1. Date of Application: 12/9/21
2. Date of Plan or Revision: 11/30/21
3. Application for: Butler Ave Mixed Use
4. Name of Subdivision or Land Development: Butler Ave Mixed Use
5. Location: 409 W. Butler Ave
6. Tax Map Parcel #: 26-005-023 Total Acreage: Gross 7.3 Net 6.6
7. Net Buildable Site Area (from Section 2401): 6.6 acres
8. Zoning Requirements:

PRELIMINARY AND FINAL LAND DEVELOPMENT PLANS

RE: Fire Marshal review Butler Avenue Property T.P. # 26005-023

BUTLER AVENUE PROPERTY
 TMP # 26-005-023
 NEW BRITAIN TOWNSHIP, BUCKS COUNTY, PA
DETAILED GRADING PLAN

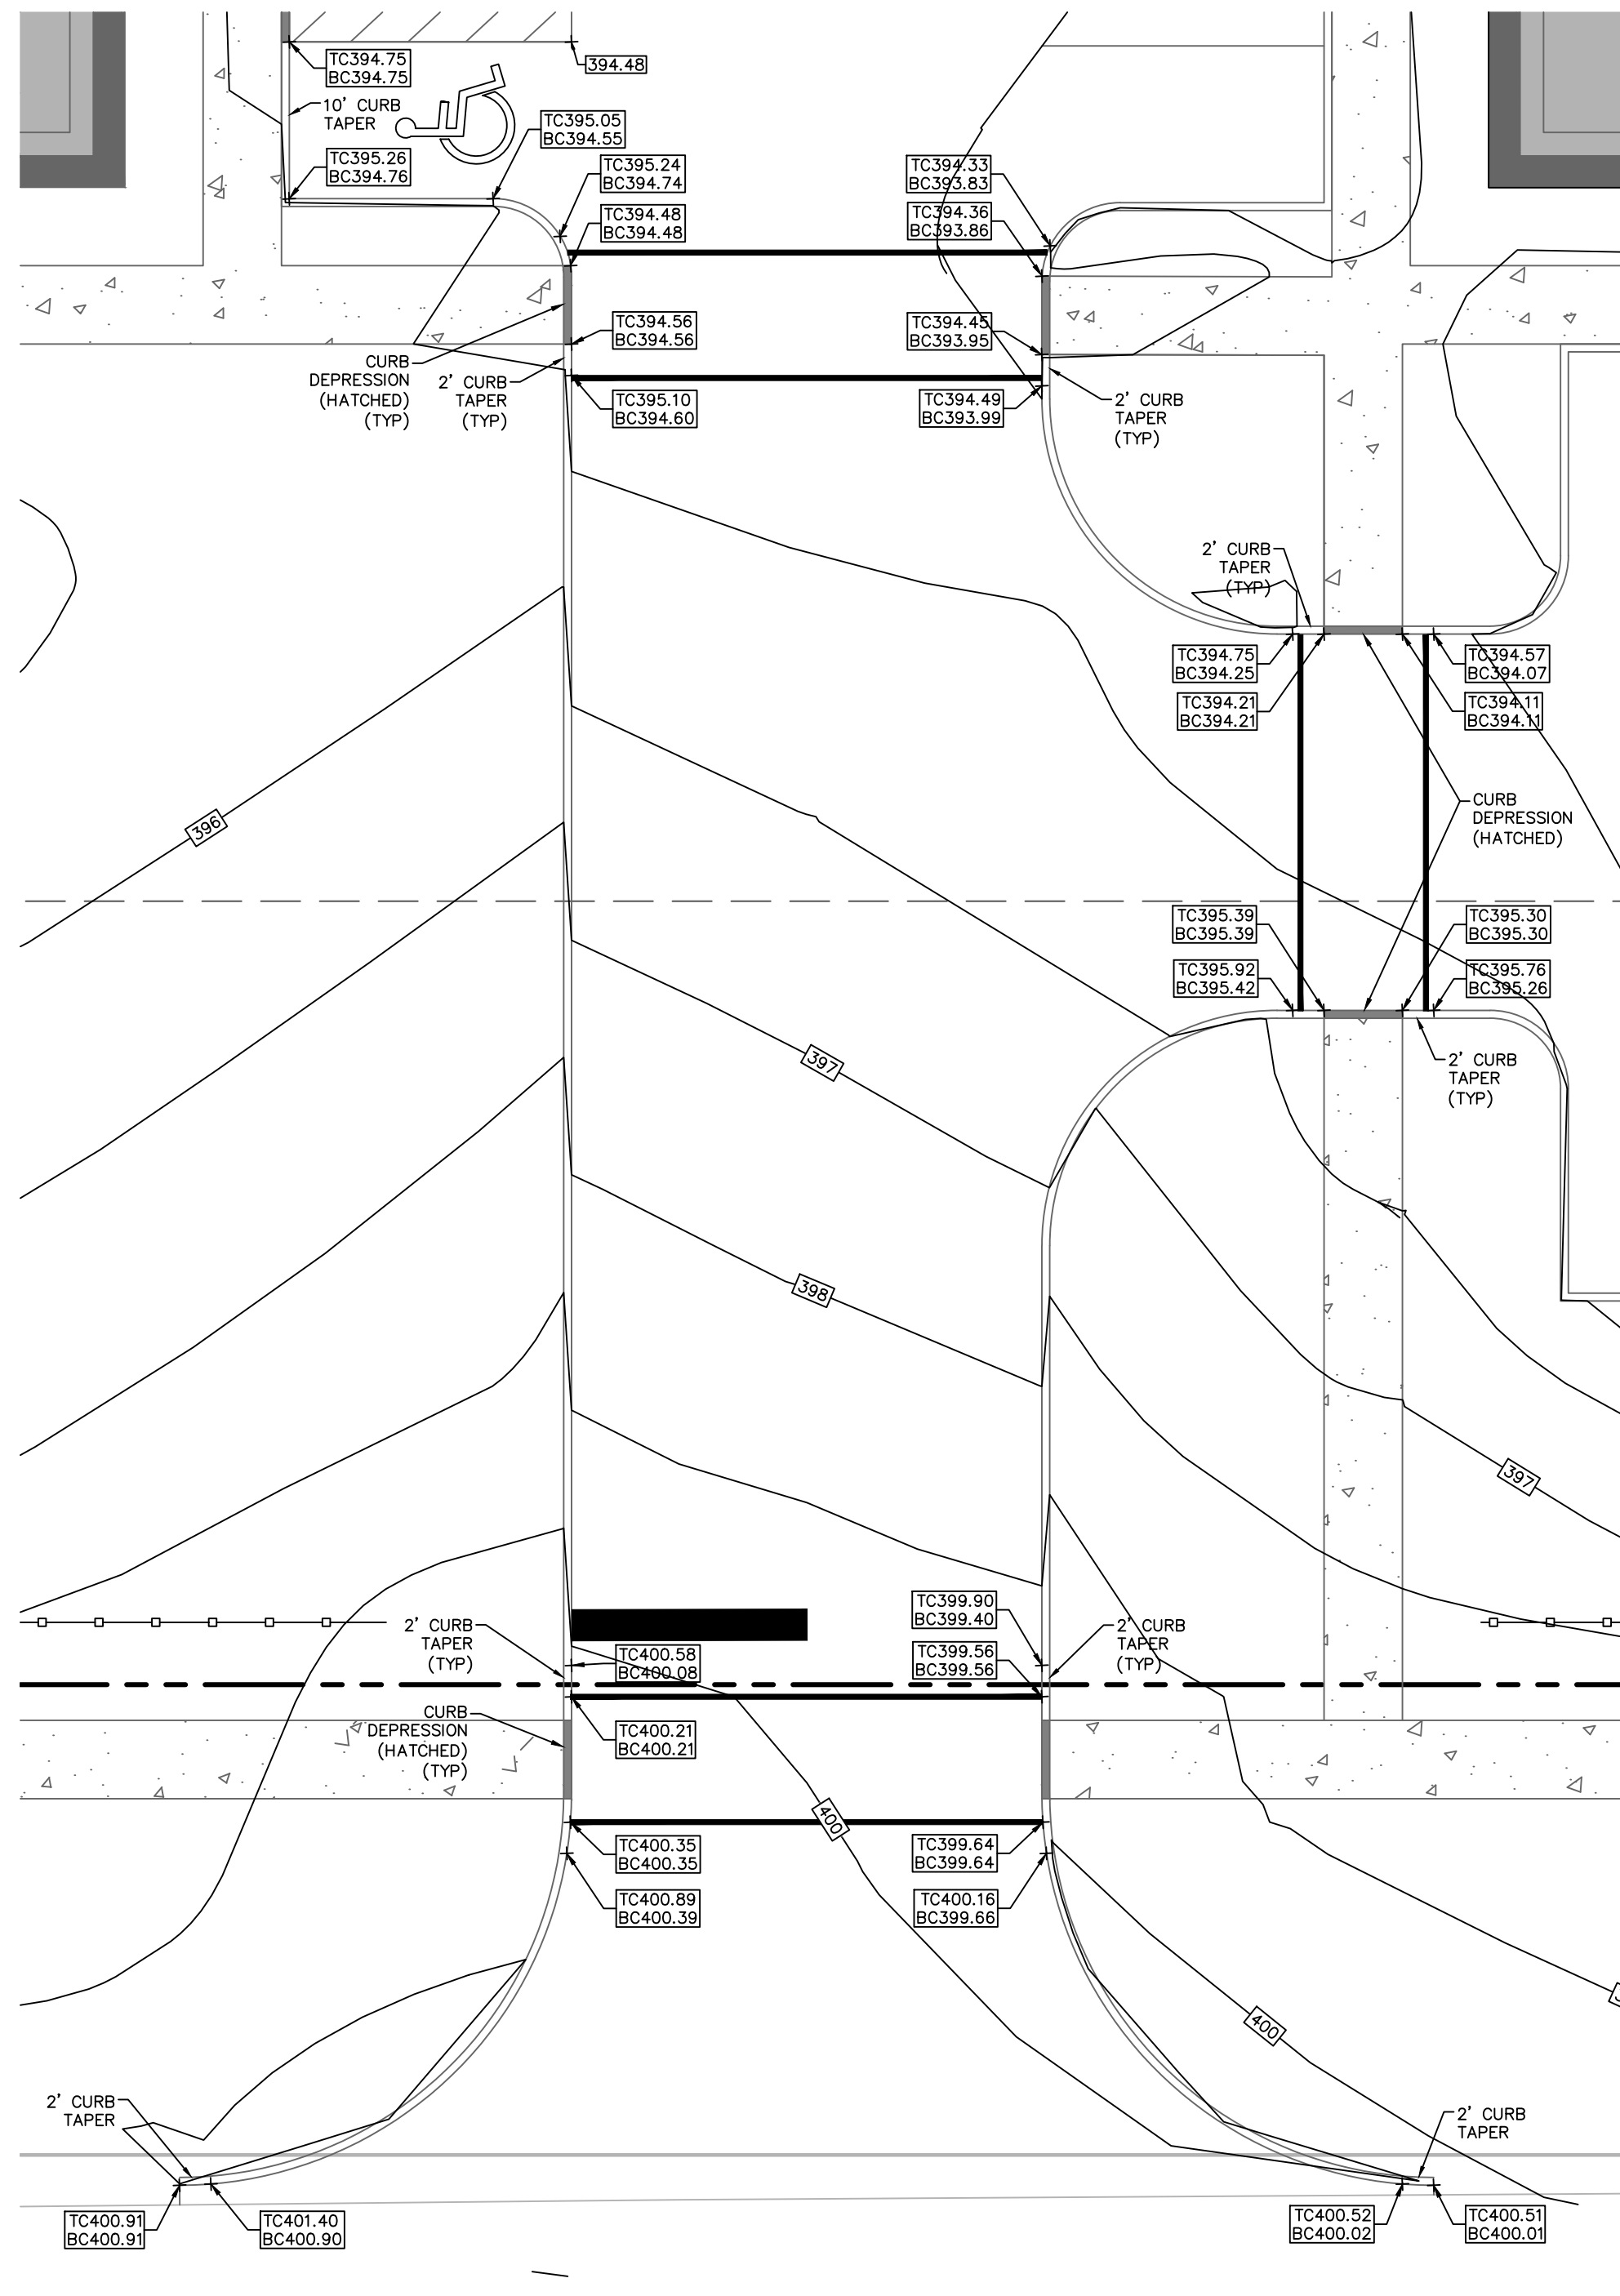
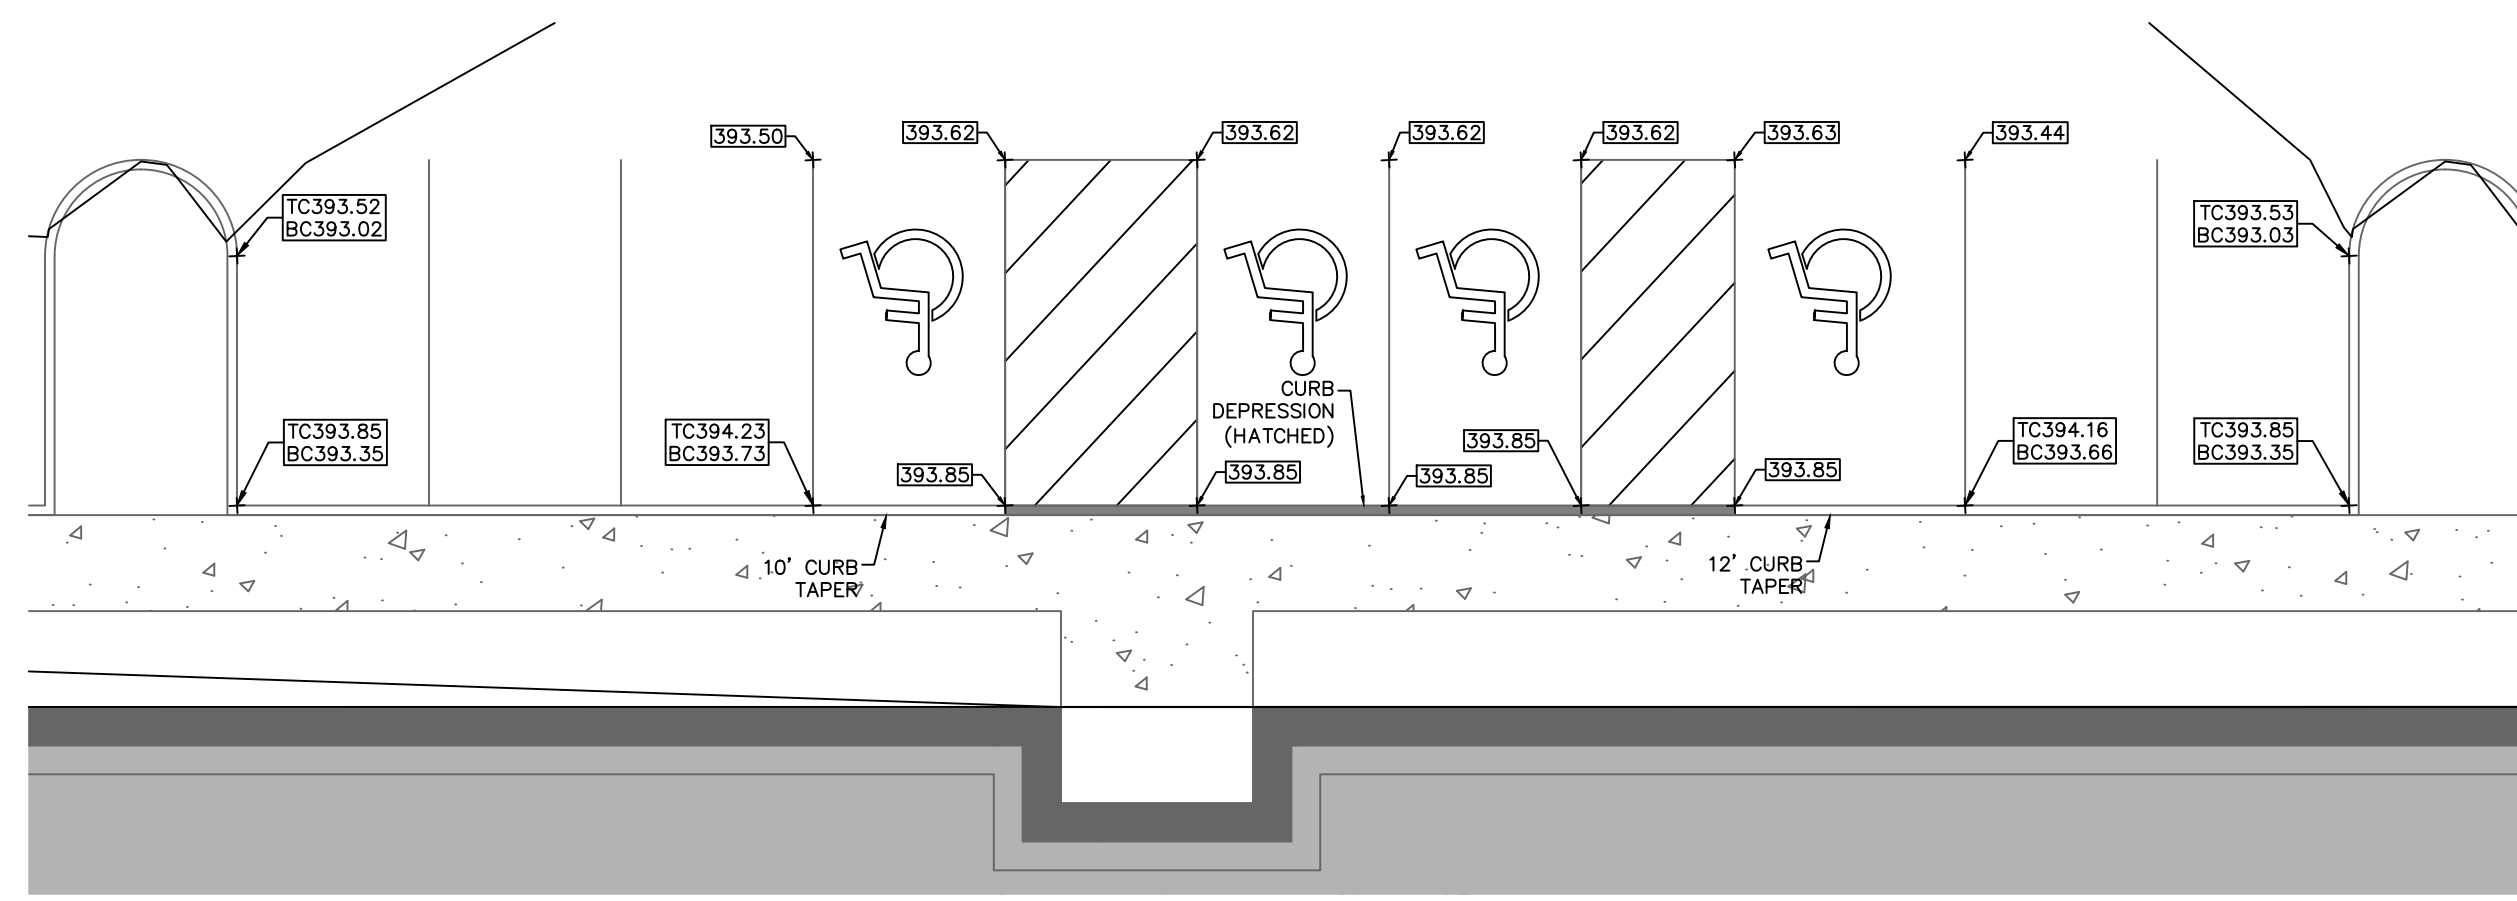
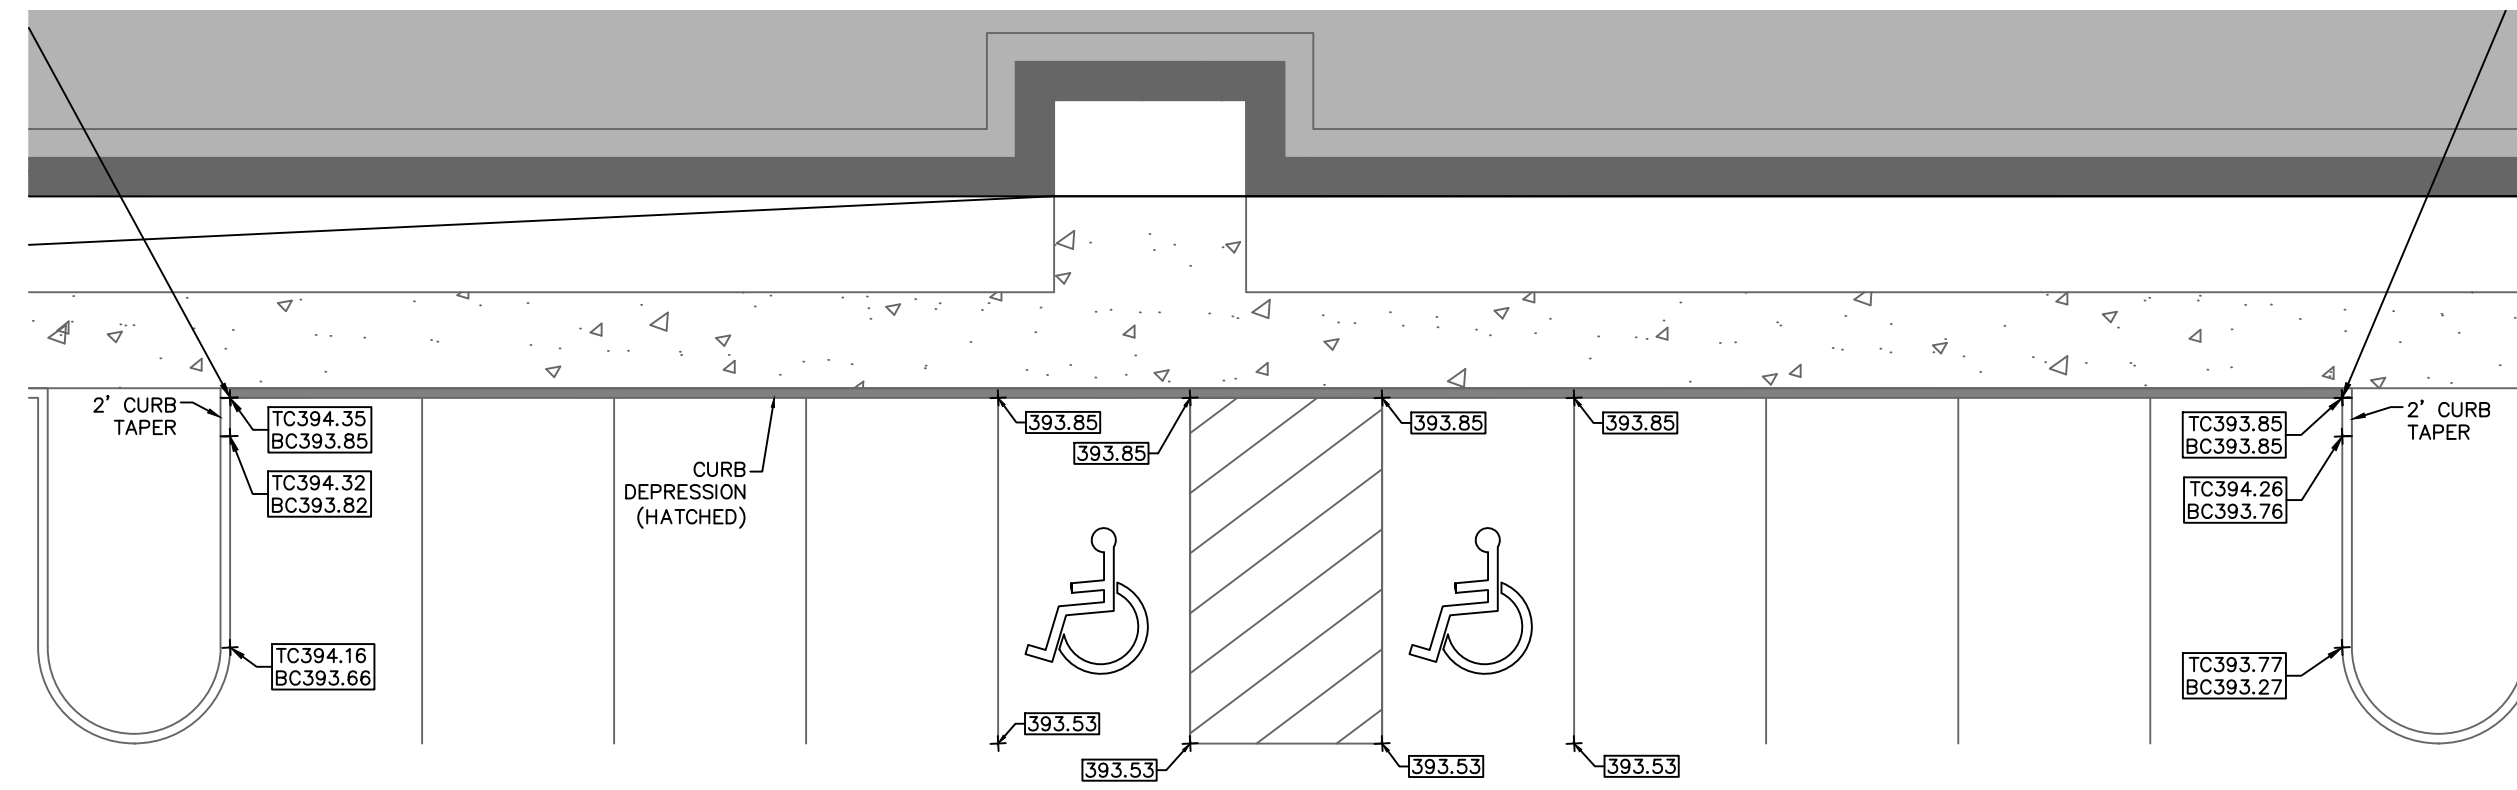
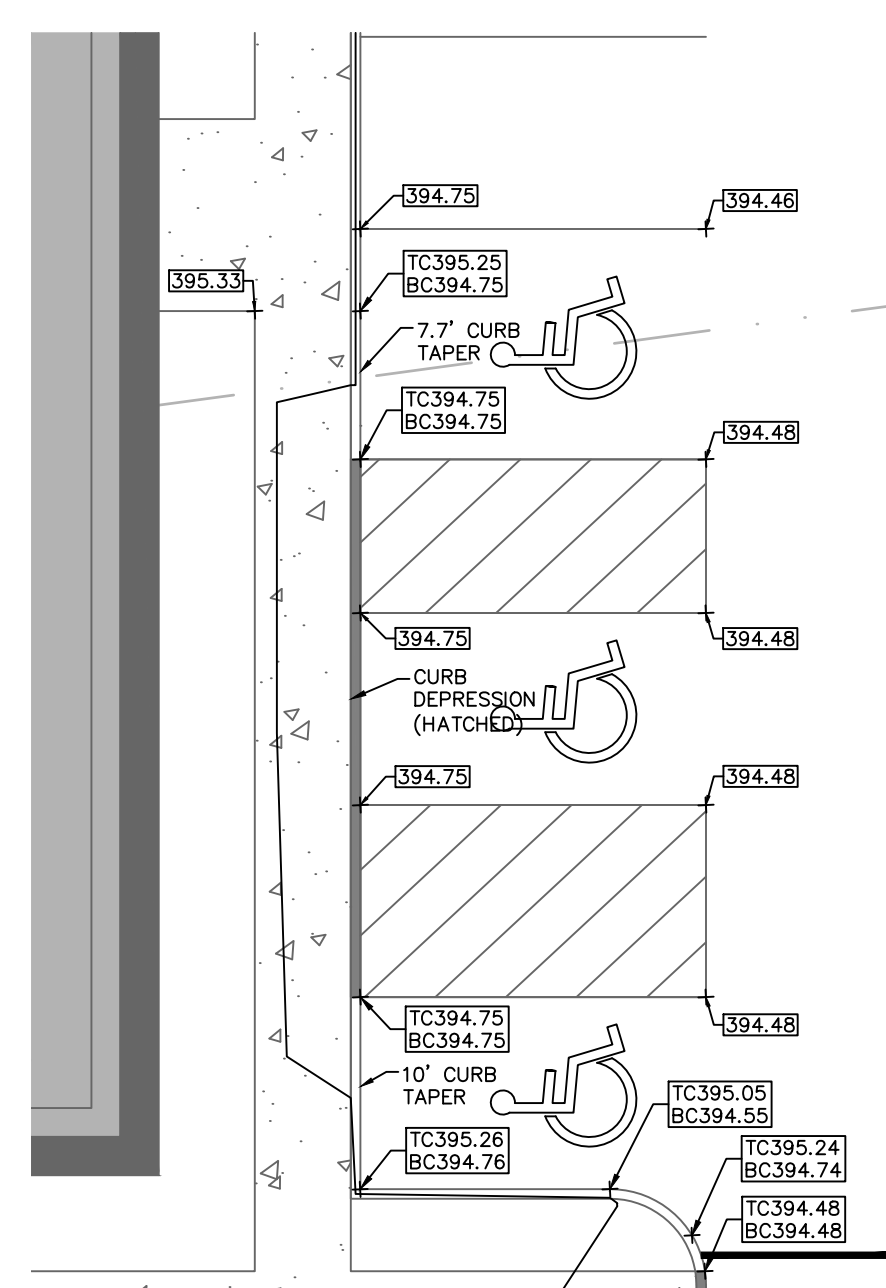
8. §27-2904.d.3 – Access driveways shall have a 6% maximum grade, except that the initial 20 feet from the edge of the cartway of a public street shall be a maximum of 3% grade. Based on the curb elevations on Sheet 7, it appears the initial 20 feet from the cartway may exceed 3%, while the remainder of the driveway has a slope of approximately 6.7 to 7.5%. The driveway grading shall be verified to clearly meet the minimum required driveway slopes.
